SERVICE BULLETIN

ADJUSTABLE COLLECTIVE DRIVE LINK REPLACEMENT

- A. Aircraft Affected: All McDonnell Douglas Helicopter Systems (MDHS) MD900 Series Helicopters, serial number 900-00002 thru 900-00051.
- B. Assembly/Components Affected by this Notice:
Adjustable Collective Drive Link Assembly (P/N 900C2010233-103, -105)
- C. Time of Compliance: The requirements of this Bulletin shall be accomplished prior to any further ground or flight operations.

Figure 1. Adjustable Collective Drive Link Assembly Installation

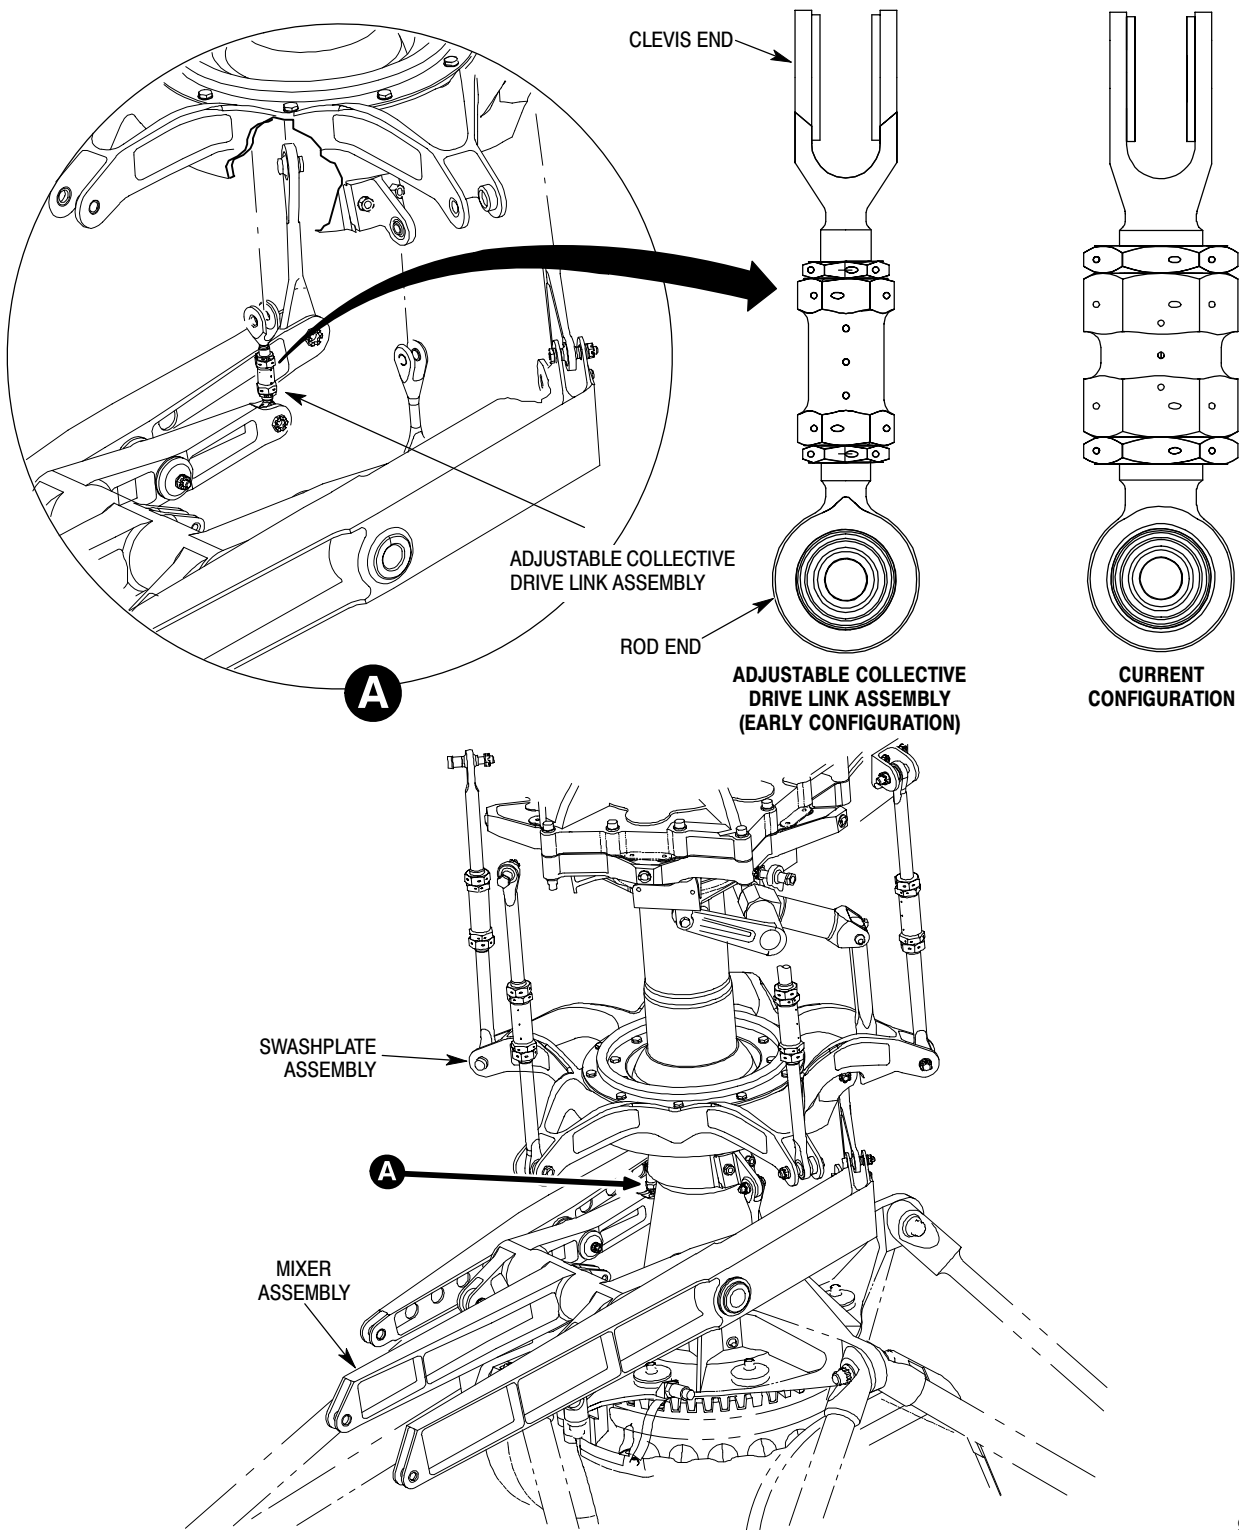
A. Remove adjustable collective drive link assembly (P/N 900C2010233-103 or -105) per instructions contained in 62-30-00 (Rev. 11 or later).

B. Install adjustable collective drive link assembly (P/N 900C2010233-107) per instructions contained in 62-30-00 (Rev. 11 or later).

The overall length may be adjusted to allow installation. If adjustment is necessary, cut safety wire, loosen both jamnuts and rotate barrel similar to PC link adjustment. Torque jamnuts to 660 - 780 inch-pounds (74.55 - 88.11 Nm) and install safety wire.
